North Valumbrosa Replat A

City Plan Commission — May 8, 2025

CASE NUMBER/TYPE: SUSU25-00039 – Resubdivision Combination
CASE MANAGER: Aaron Andaluz, (915) 212-1585, AndaluzA@elpasotexas.gov
PROPERTY OWNER: Alfredo Medina
REPRESENTATIVE: Dorado Engineering, Inc.
LOCATION: East of Zaragoza Rd. and North of Alameda Ave. (District 7)
PROPERTY AREA: 0.50 acres
VESTED RIGHTS STATUS: Not Vested
PARK FEES: \$2,740.00
EXCEPTIONS/MODIFICATIONS: Yes, see following section
ZONING DISTRICT: R-4 (Residential)
PUBLIC INPUT: Two calls of inquiry received as of 5/1/2025

SUMMARY OF RECOMMENDATION: Staff recommends **APPROVAL** of North Valumbrosa Replat A on a Resubdivision Combination basis and **APPROVAL** of the following two (2) exceptions:

EXISTING CROSS-SECTIONS:

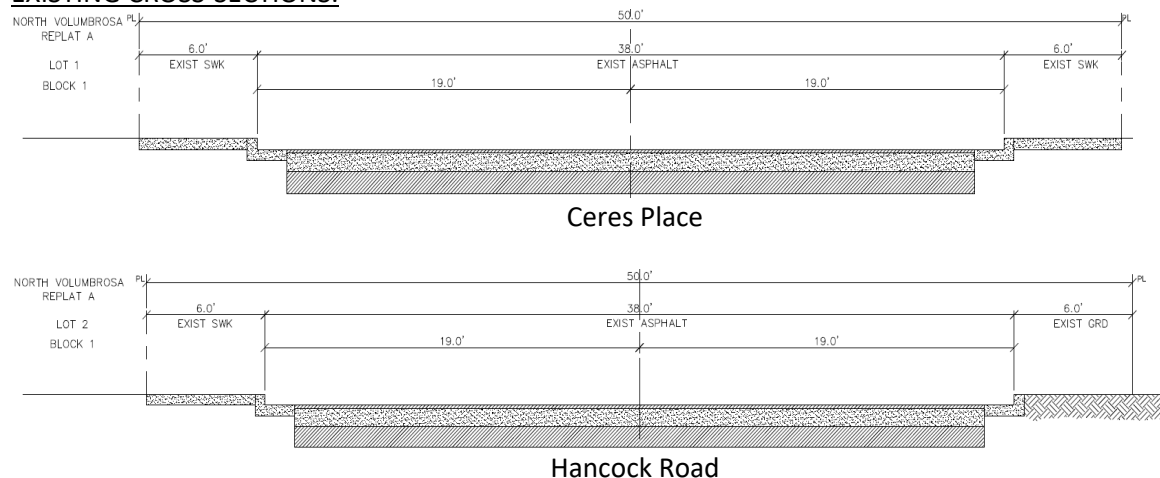
EXCEPTIONS, MODIFICATIONS, OR WAIVER REQUESTS: The applicant is requesting two (2) exceptions, pursuant to El Paso City Code 19.10.050.A.1.a – (Roadway participation policies—Improvement of roads and utilities within and or abutting the subdivision). The exceptions include the following:

- The construction of five feet (5') of planter strip along Ceres Place.
- The construction of five feet (5') of planter strip along Hancock Road.

9. Rename "Middle Drain" to "Pueblo Viejo City Park" on plat, or add park name in addition to the R.O.W. name.
10. Correct the typo in the word "DRIVABLE" under both Ceres Place and Hancock Road cross-sections.

EVALUATION OF EXCEPTION REQUEST: The exception request to waive right-of-way improvements meets the following criteria under El Paso City Code 19.10.050.A.1.a. The section reads as follows: The City Plan Commission may waive such requirements to provide rights-of-way or street improvements to adjacent substandard roads based on any of the following factors:

- Fifty per cent of the lots within a quarter mile of the proposed development have already been developed and the existing street improvements are in character with the neighborhood.

Figure B: Developed properties within a quarter mile of proposed subdivision

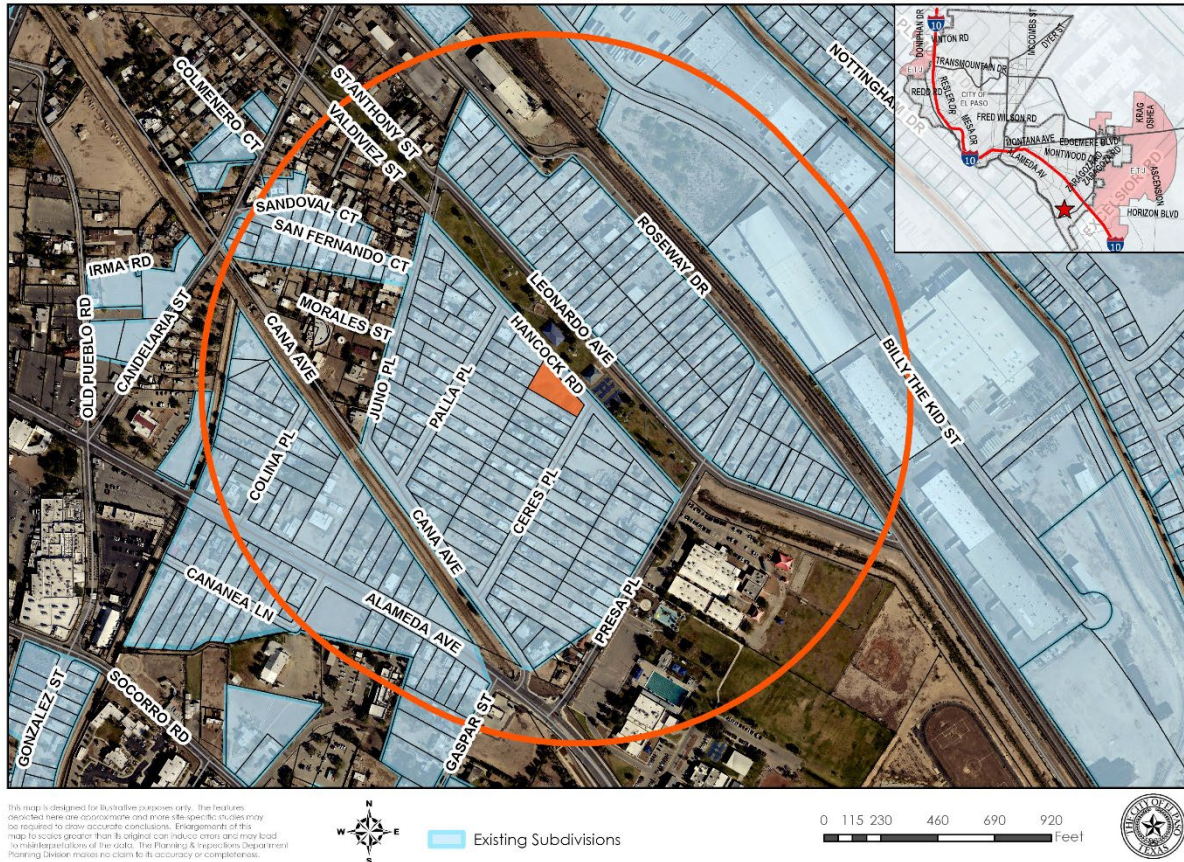
The reason for this request is to maintain existing conditions. Granting the waiver or exception will not be detrimental to the public health, safety or welfare, or injurious to other property within the area and will not have the effect of preventing the orderly use and enjoyment of other land within the area in accordance with the provisions of this title, or adversely affect the rights of owners or residents of surrounding property.

BEING ALL OF LOTS 48 & 49
NORTH VOLUMBROSA
CITY OF EL PASO
EL PASO COUNTY, TEXAS
CONTAINING 0.504 ACRES

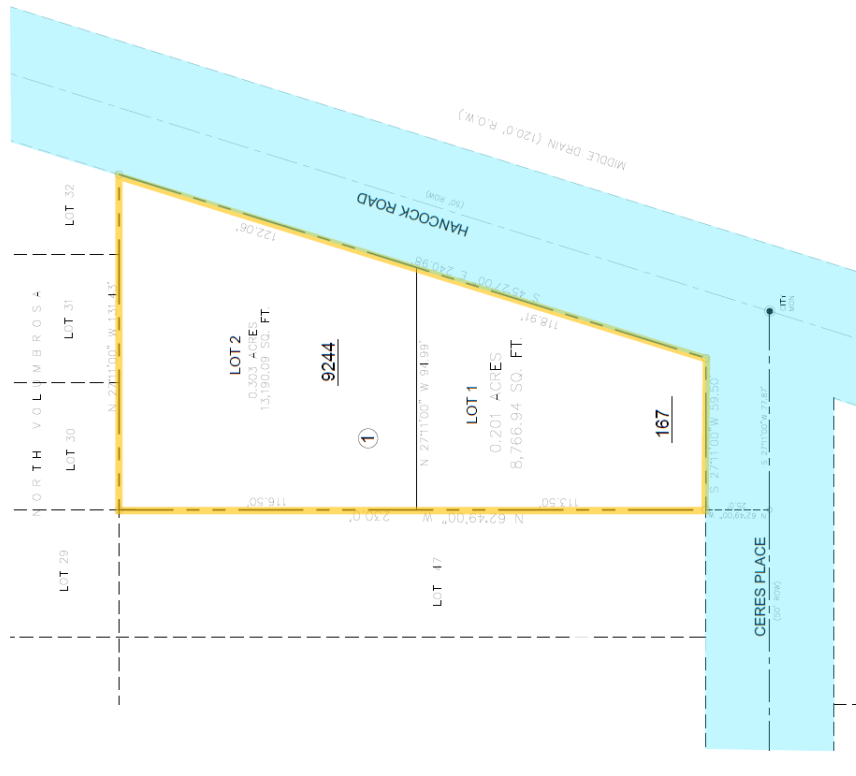
- b. Release of access document, if applicable.
 - c. Set of restrictive covenants, if applicable.
2. Add a 10' wide easement for the existing line along Hancock Rd and along the proposed lot split of Lots 1 and 2.

3. Consider rotating the subdivision 90° to the left, so that it better aligns with north direction.
4. Correct all misspellings of "Valumbrosa" in application and in plats (including in the legal description).

5. Add contour lines to preliminary plat.
6. Add basis of North direction to plat notes.
7. Correct N 27°11'00" W 131.43 to N 27°11'00" E 131.43.
8. Add distance from centerline to Ceres Place and Hancock Road rights-of-way on plats.

1. Verify if subdivision boundary line N 27d11'00"W 131.43' should be NE.
2. Label type of found or established survey points used to delineate the subdivision boundary.
3. Boundary closure report is ok.

Please add a 10' wide easement for the existing line along Hancock Rd and along the proposed lot split of Lots 1 and 2.

EPCWID No. 1 has no objections. Please correct the legal on the subdivision.
